**\*\*\*\*\*RECALL NOTICE\*\*\*\*\***

**NHTSA Recall # 07V-056**

<b>Tire Selection and Rims (Tire and Loading Information)</b>		<b>RECALL#07V-056</b>	
BY: Jose Vasquez	DEPARTMENT: Warranty/ Recalls	DATE: 11/10/2009	REVISION: 2

Figure 2

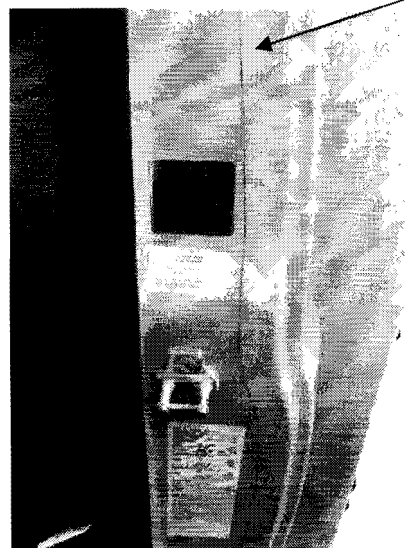
1. Open the Drivers door and inspect the door **B** pillar as indicated below in **Figure 2** for the *Tire and Load Information Decal*.
2. Inspect the vehicle for the missing label and fill out the prepaid response Card. TCI will send the required label to you.
3. If the vehicle is missing the decal, attach the decal provided as shown in **Figure 1** on to the driver's door pillar as indicated in **Figure 2**.
4. Once either the vehicle decal as been affixed to the pillar or verification that the decal is not required, fill out the form on the 2<sup>nd</sup> sheet and send back to Transportation Collaborative Inc in the return envelope provided.

Affix Decal Here

The remedy for this recall is to simply affix the tire and loading information decal to the driver's door pillar. Transportation Collaborative Inc on behalf of US Bus Corporation will provide the customer with the proper decal and information.
